**CAPITOL ZONING DISTRICT COMMISSION  
STAFF REPORT  
8/24/16  
BIM/ TDM**

**Location:** 204 – 206 South Bishop Street and 1706 – 1724 West Third Street  
**Applicant:** John Johnson for Mullenix Land Company  
**Permit Types:** Certificate of Appropriateness with Height Review and Conditional Use Permit

**Project Description:** This application is for a Certificate of Appropriateness to allow for the removal of the Precision Motors building (along with a small ancillary structure) at 204 South Bishop, and the construction of a new four-story mixed-use building and related site improvements. The proposed new building features a contemporary design with walls made of scored concrete stucco and cementitious fiberboard siding, a masonry foundation, and a flat roof. The application also proposes to use the property at 1706 West Third for parking and to develop the wooded parcel at 1724 West Third as a new parking lot. [Note- updated renderings based on feedback from staff and committees are on Pages 31-32 of this report.]

**1 SOUTH**  
 1/8" = 1'-0"

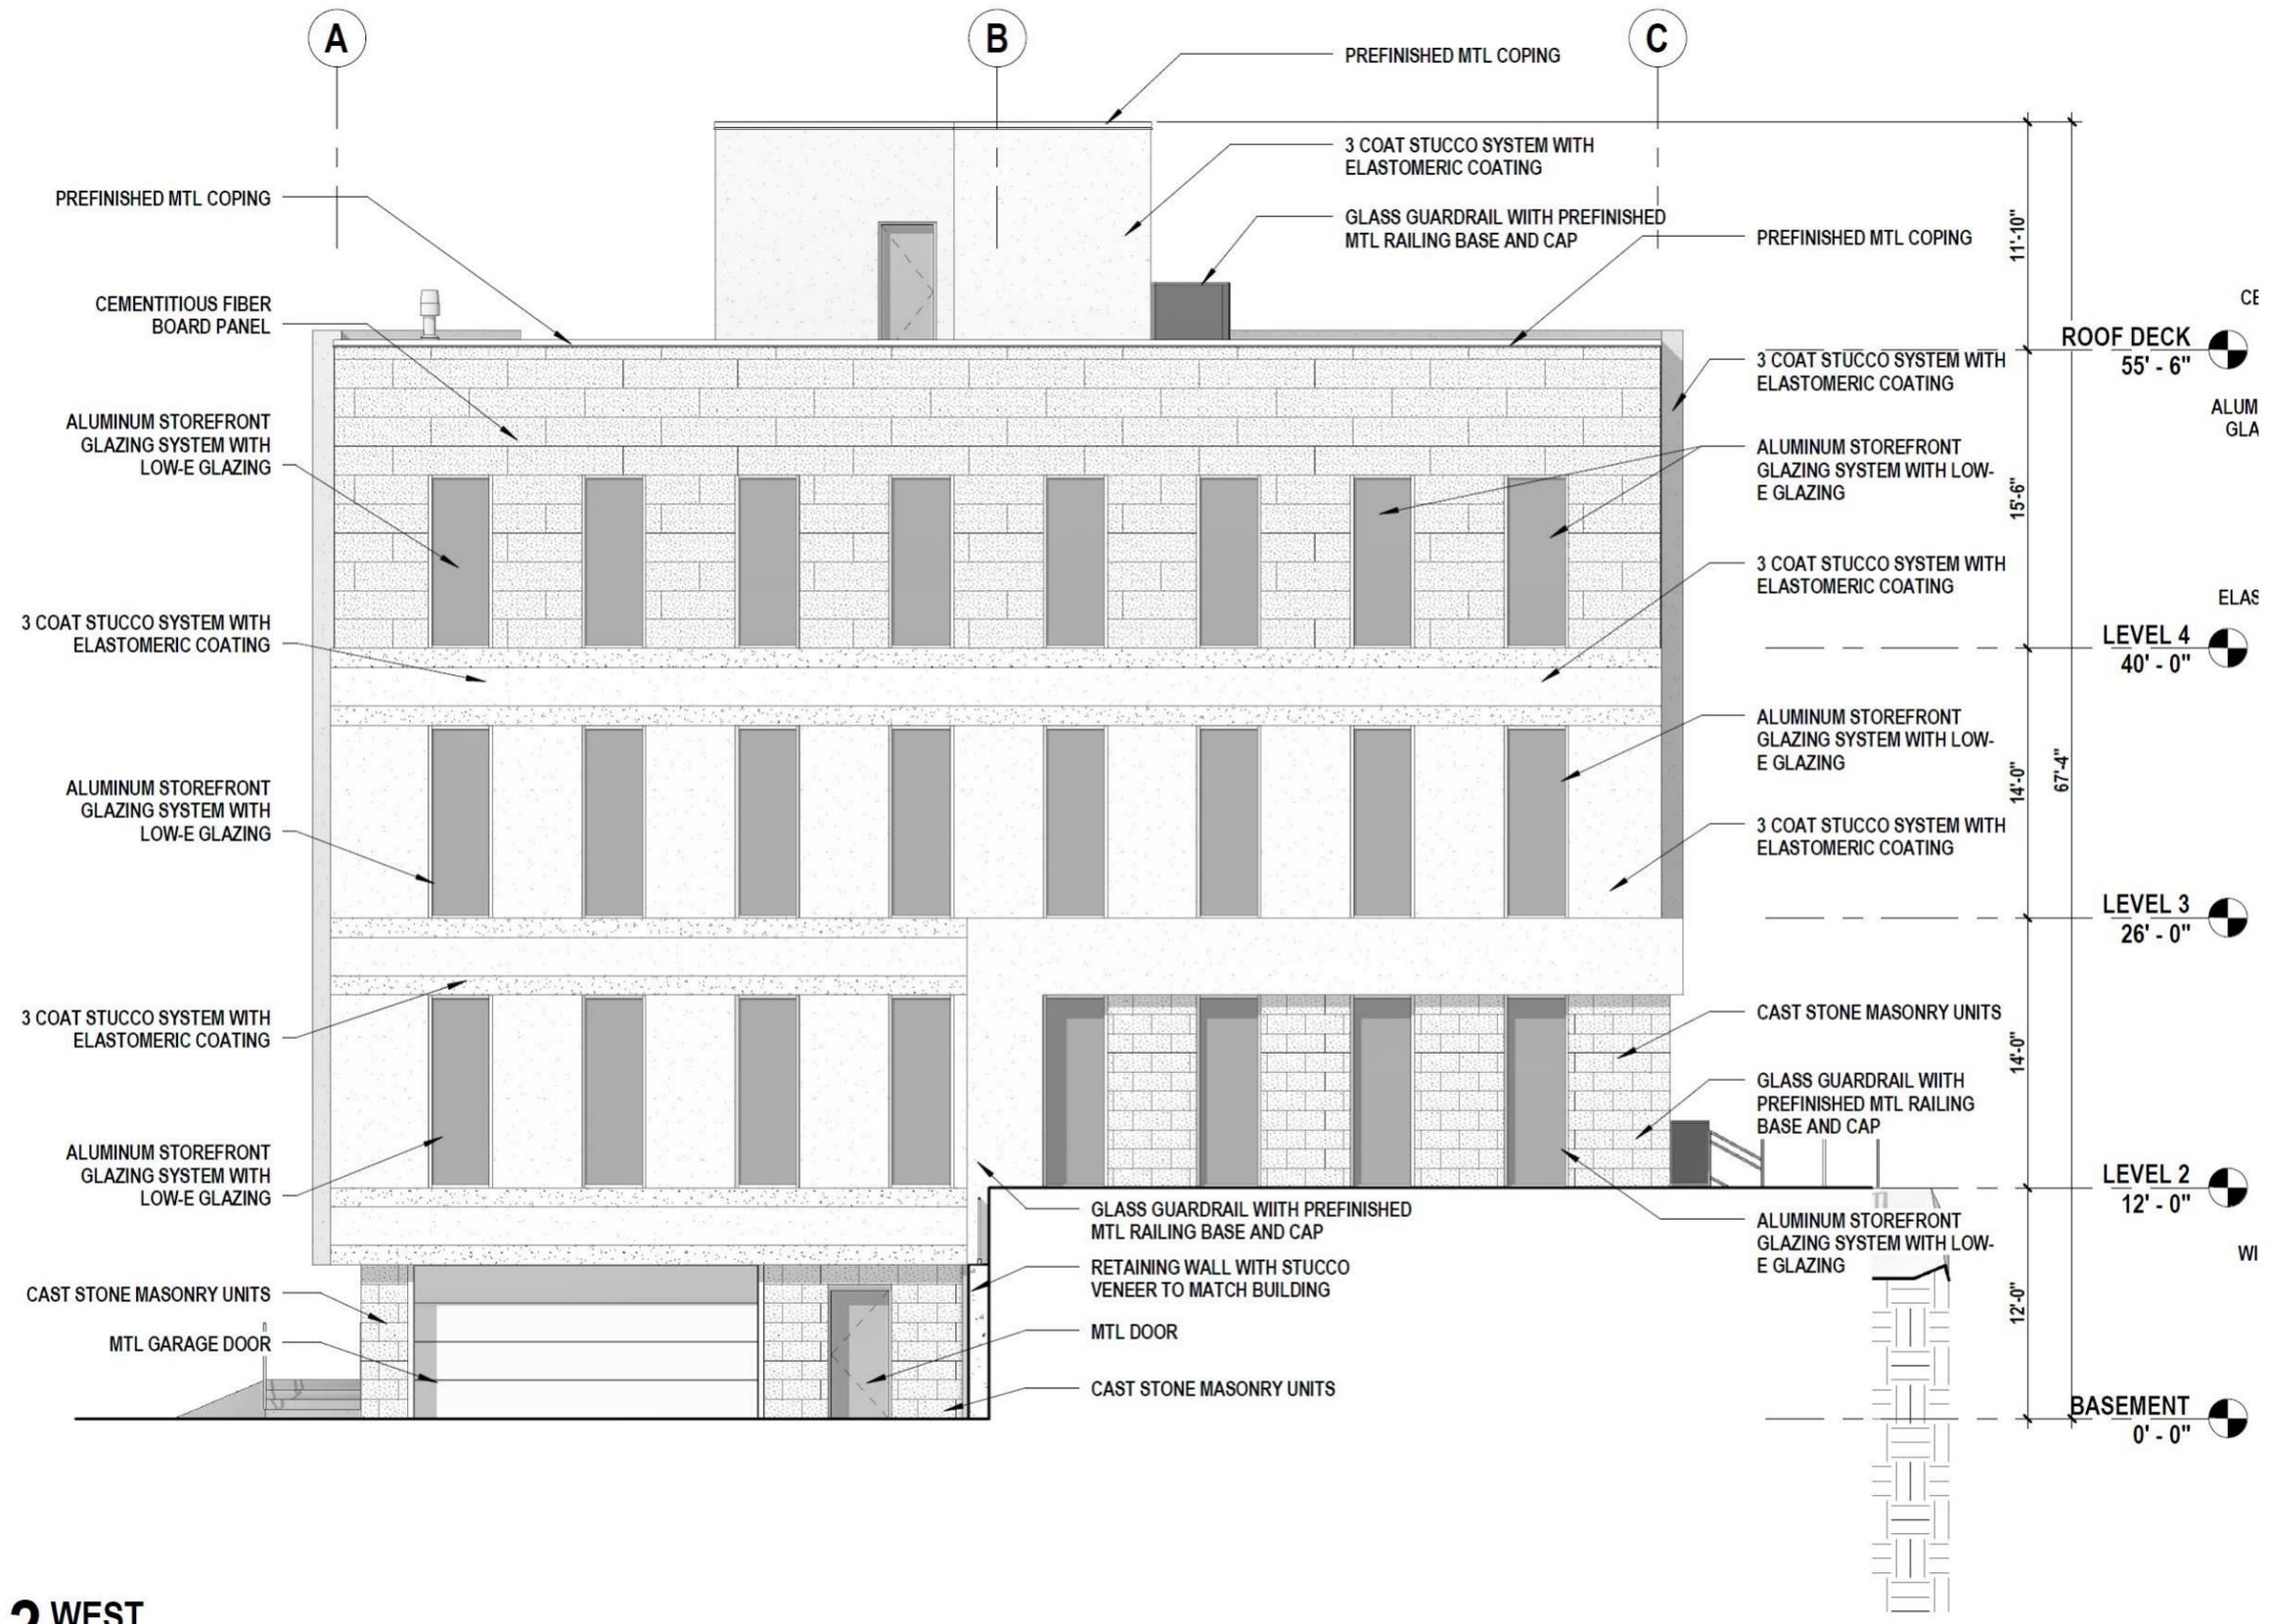
*Staff finds the proposal is consistent with this standard. The recessed entry at the southeast corner of the building adds some visual interest to the building's street face, as does the recessed basement level. The applicants also propose a landscape strip between the sidewalk and building along Bishop.*

*Staff finds the proposal is partially consistent with this standard. The slope of Bishop Street makes such an arrangement difficult to execute. The building does include a recessed entry but no traditional storefront glass.*

*Staff finds the proposal is not consistent with this standard. The proposed four-story building is significantly taller than the other one-story structures nearby.*

*Staff finds the proposal is not consistent with this standard. The proposed primary material is stucco.*

*Staff finds the proposal is partially consistent with this standard. The use of stucco could comply with this standard if details are cast or scored into the surface to break up large expanses of material.*

*Staff finds the proposal is partially consistent with this standard. The recessed entry on the first floor complies, but little else on the building constitutes a traditional façade element.*

- 1) That all state and city codes be followed at all times;
- 2) That the property be maintained in a neat and safe condition at all times;
- 3) That 10 parking spaces at either of the Third Street parcels be designated with signage to identify their association with the new Bishop Street building;
- 4) That at least one parking space be designated for carpool use near the back entrance;
- 5) That the City of Little Rock landscape administrator approve the parking lot landscaping plan prior to Commission staff issuing the permit.
